ADDENDUM NO. 1
January 27, 2026

ValePointe Phase I Improvements
Valley Center, KS

From: Short Elliott Hendrickson Inc.
15750 Dodge Rd, Suite 304 Omaha, NE 68118

CONCRETE FLUME DETAIL

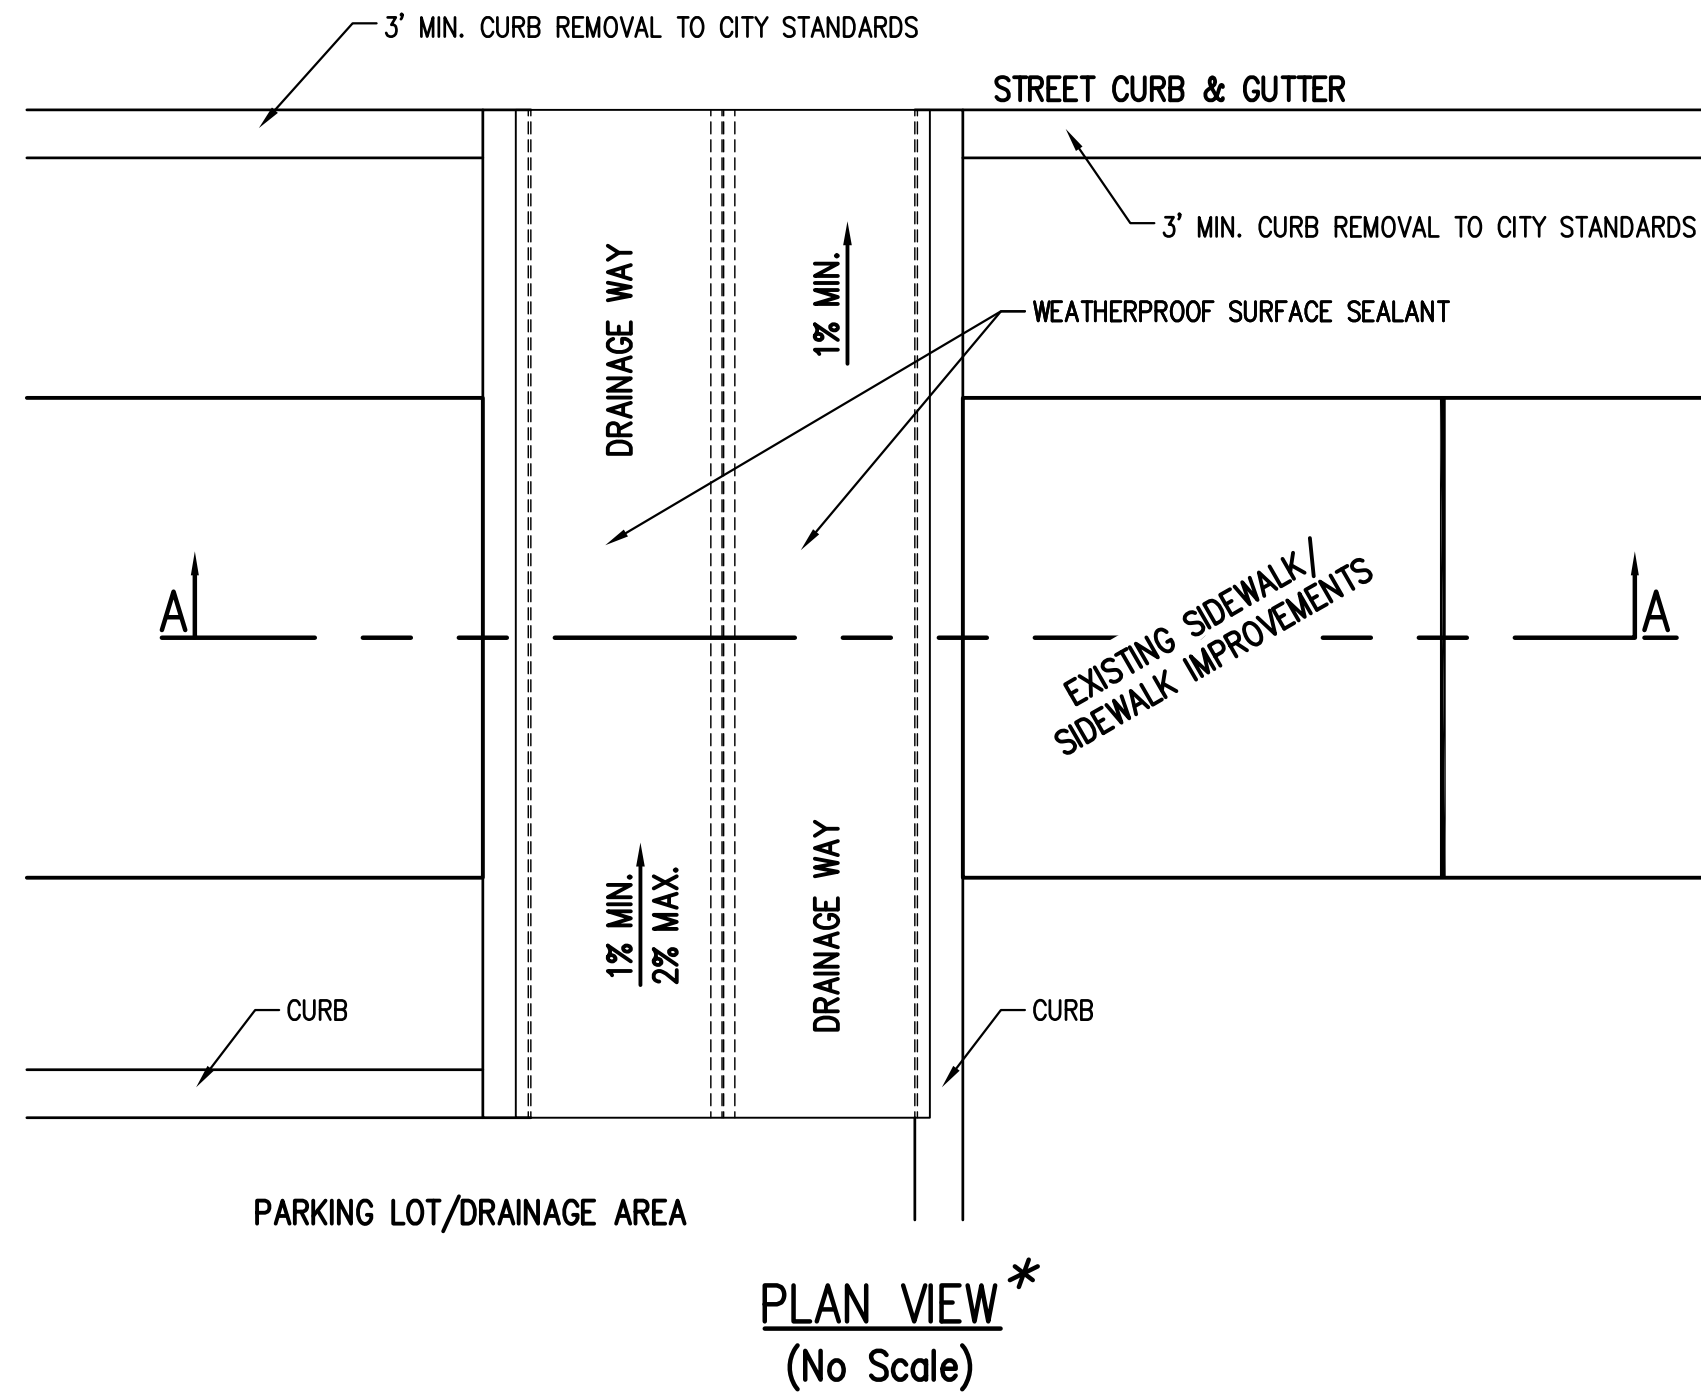
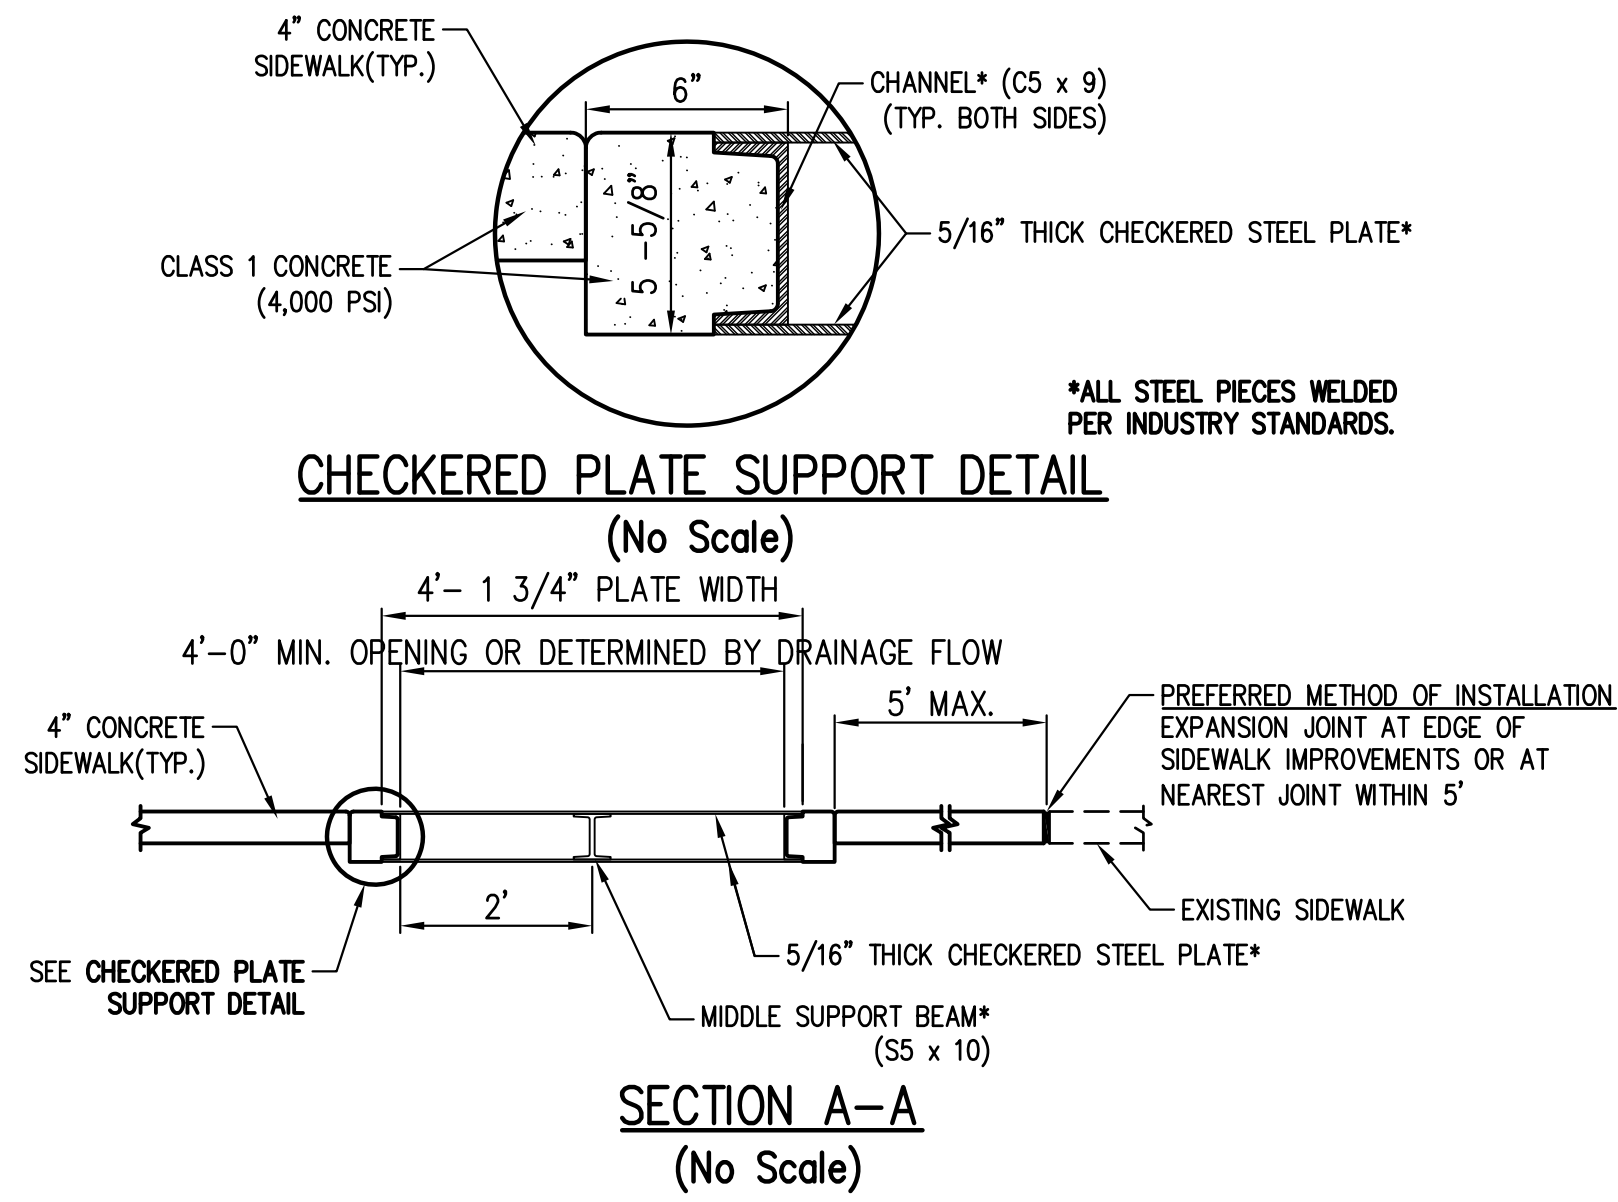
13. As a point of clarification, on the 12" Sanitary Sewer Pipe near station 1001+30, there is an existing water main laying North-South. It is believed to be a 12" PVC Water Main at a depth of 5-6'. Contractor shall not disturb this water main, and build Sanitary Sewer Pipe to the called out depth on the plans, below the existing water main.
14. Update: Bid Item #14 in Group A shall be 18" RCP, Class III with ASTM C443 Gasketed Joint.
15. Flume detail is shown below. Flume shall be reinforced with WWF 6x6, W4xW4

REVISED MARCH 2017			
COVERED CONCRETE FLUME THROUGH SIDEWALK & NEENAH CURB DRAIN			
CITY ENGINEER GARY JANZEN, P.E.			
PROJECT NUMBER	OCA NUMBER	DATE 01/2015	
CITY ENGINEER'S OFFICE CITY HALL - SEVENTH FLOOR 455 NORTH MAIN STREET WICHITA, KANSAS 67202-1620 (316) 268-4501		DESIGN	DRAWN
		SHEET

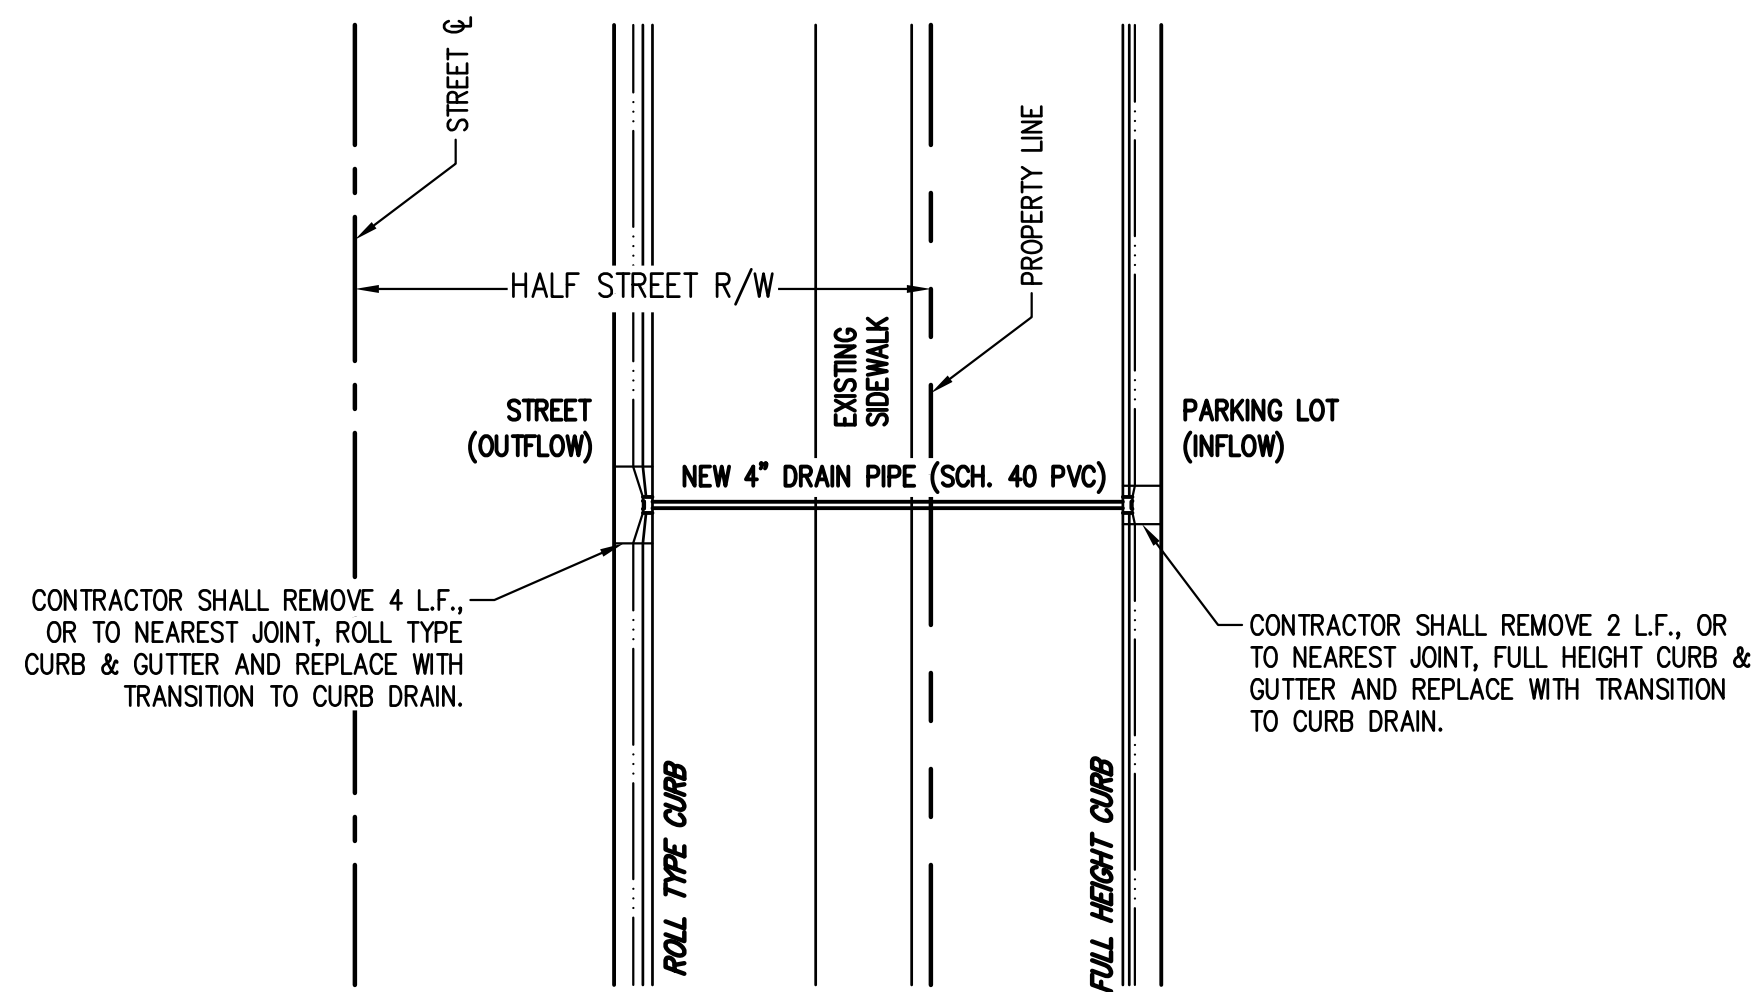
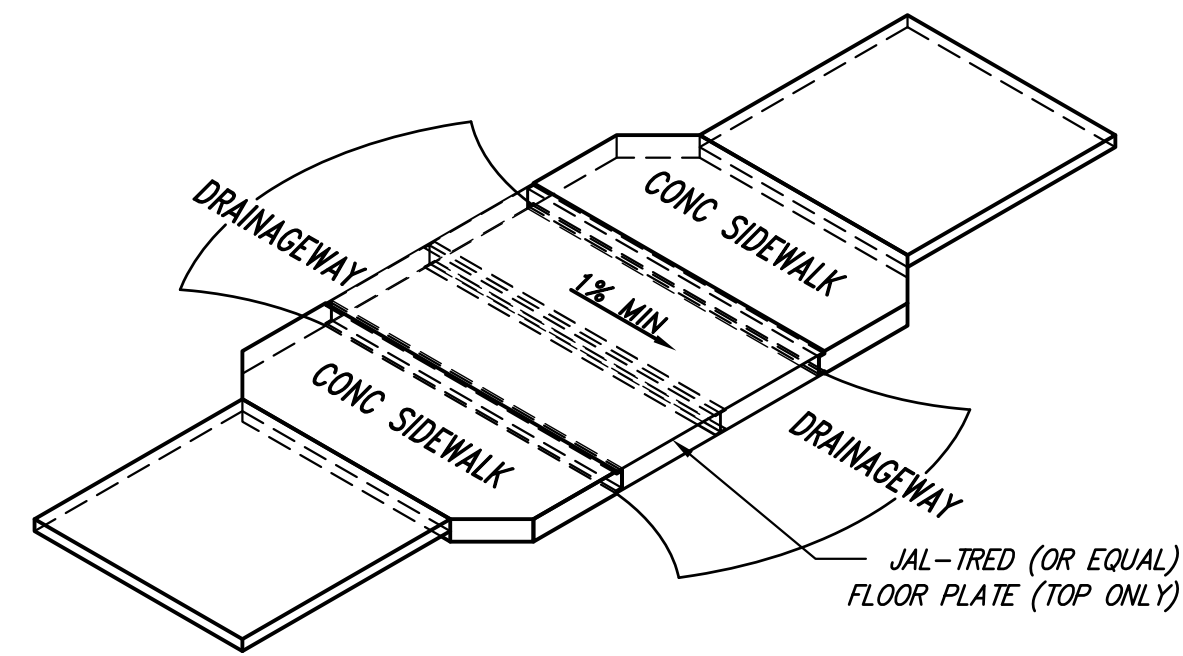
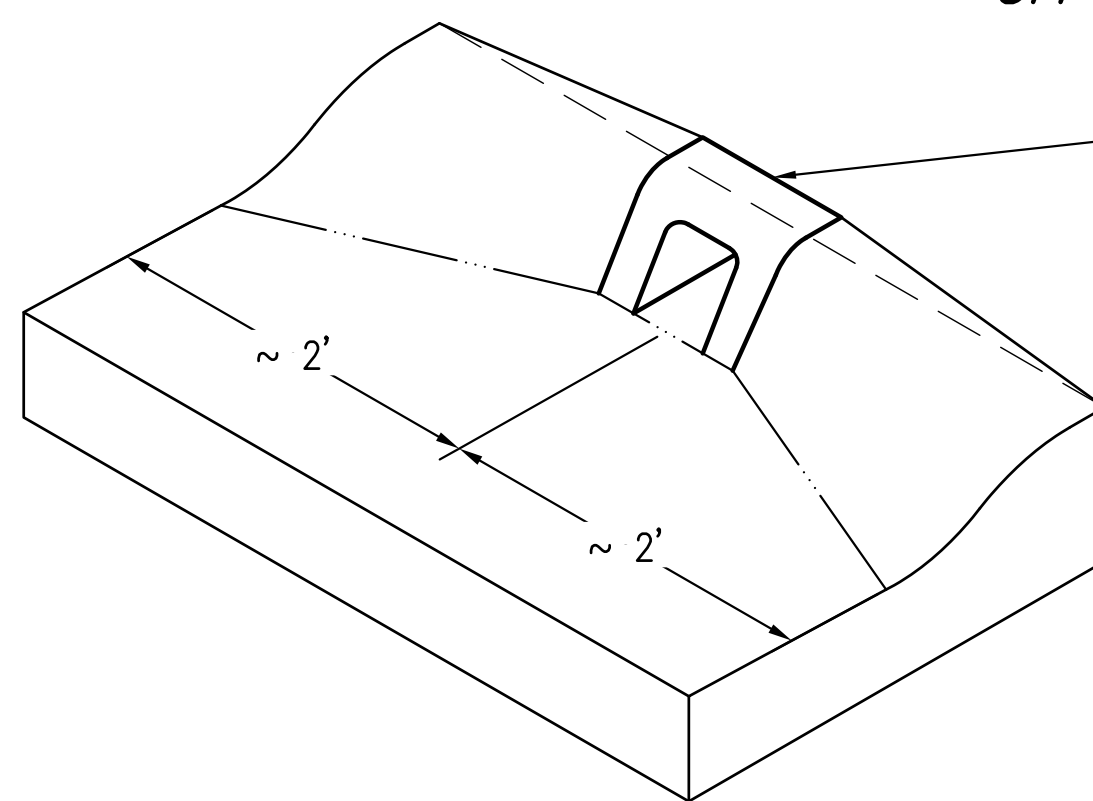
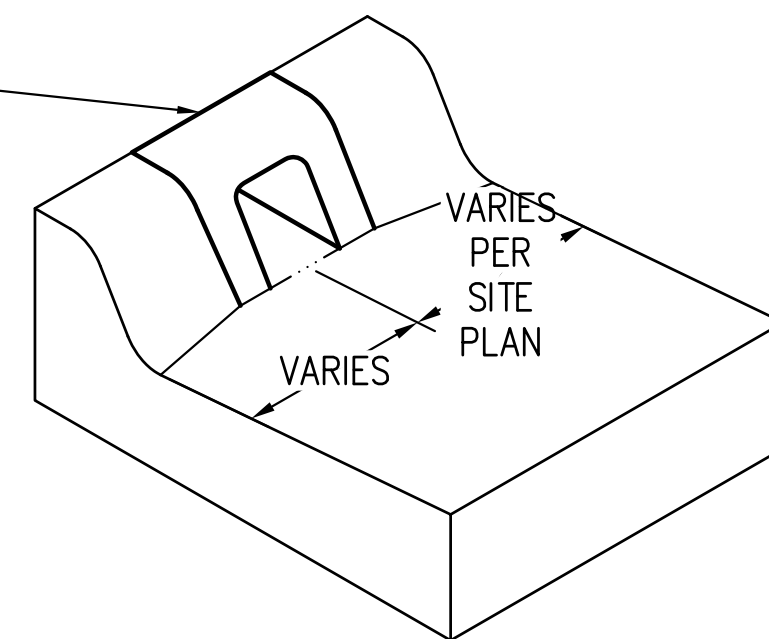
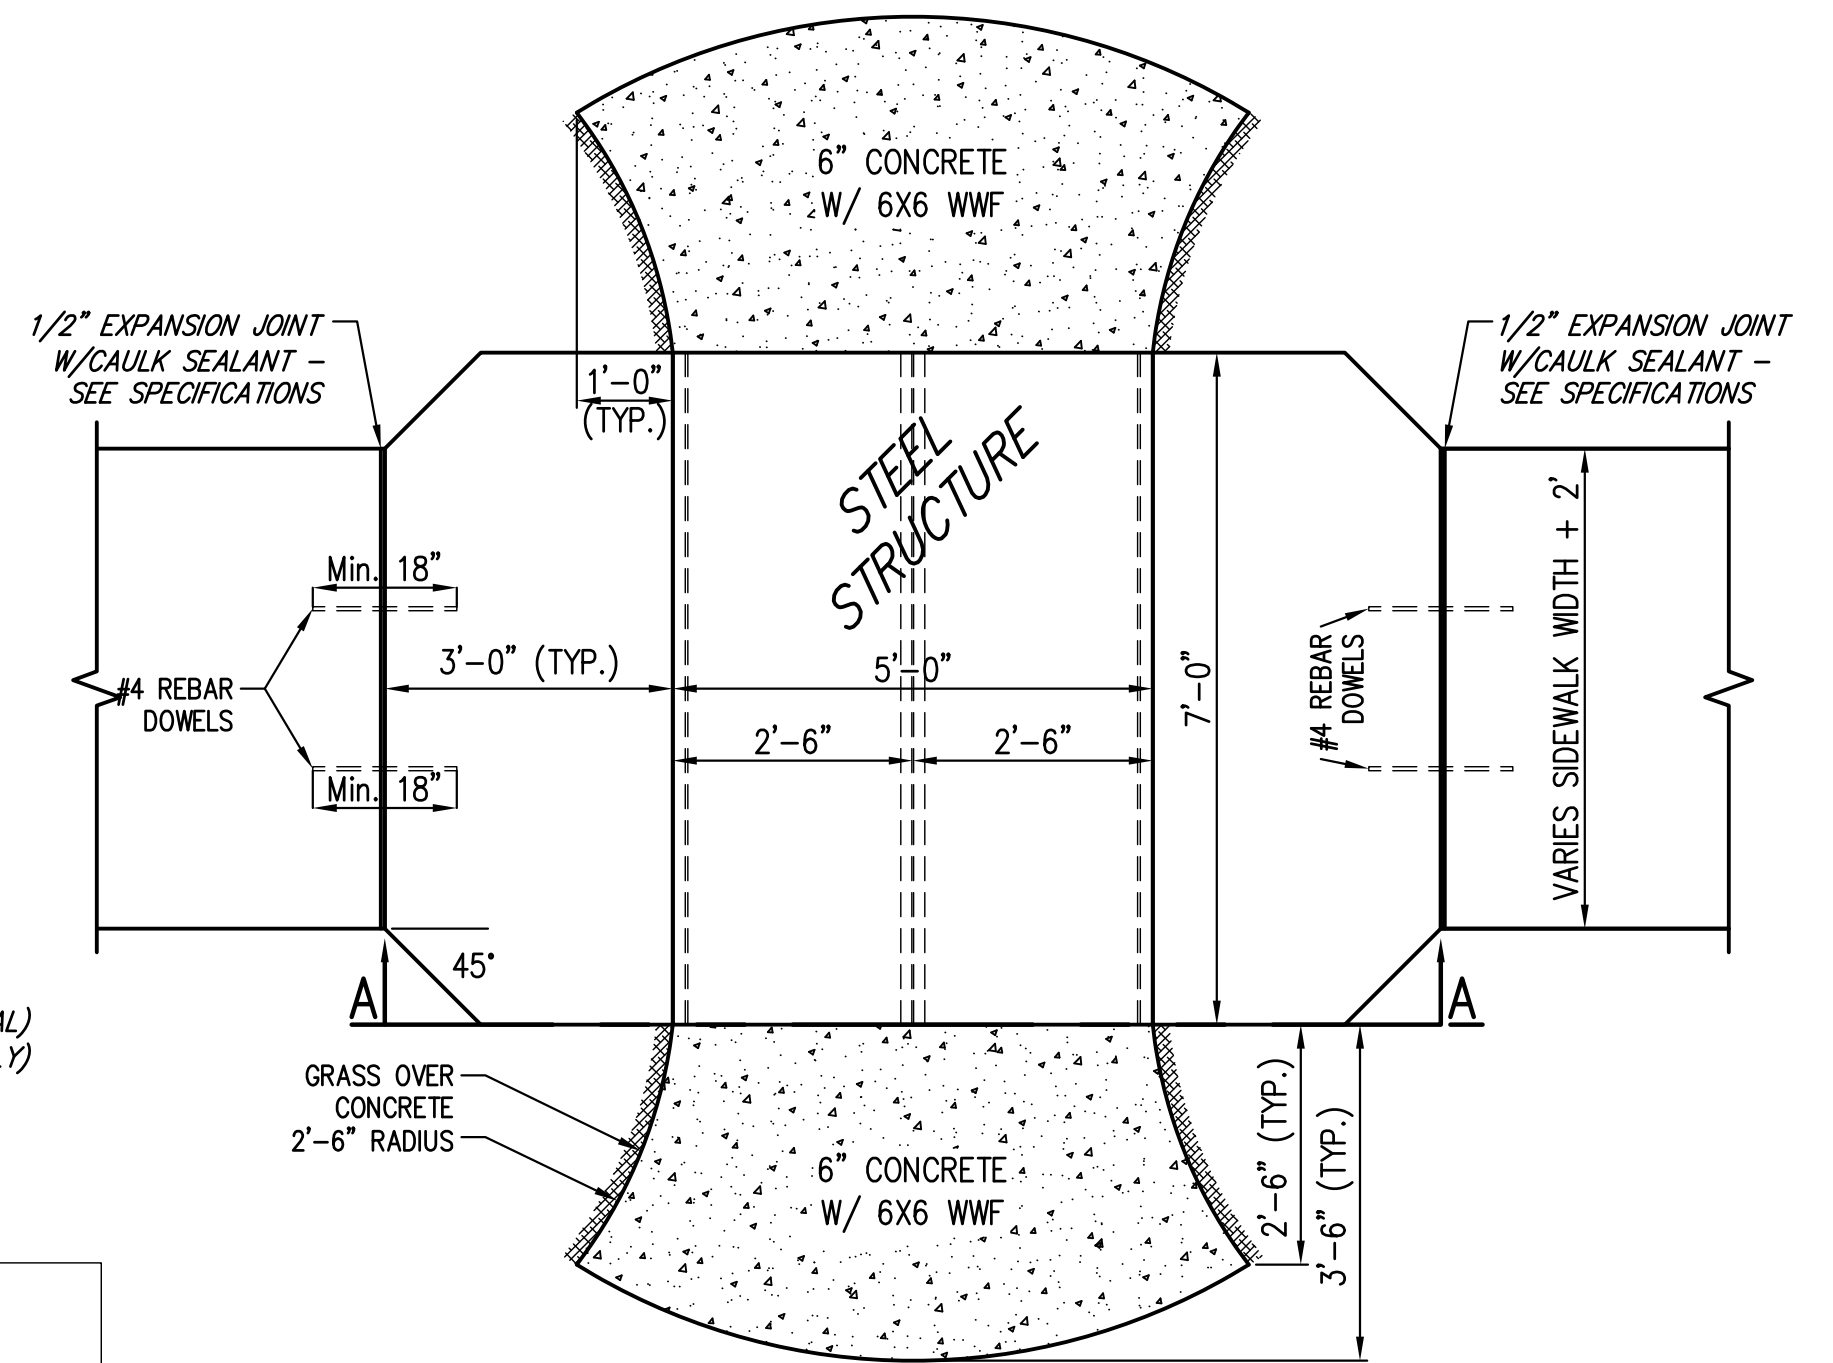
11. The Concrete Flume Through Sidewalk shall be for all materials and labor to construct a flume meeting the specifications of the attached detail (City of Wichita Standard Detail).
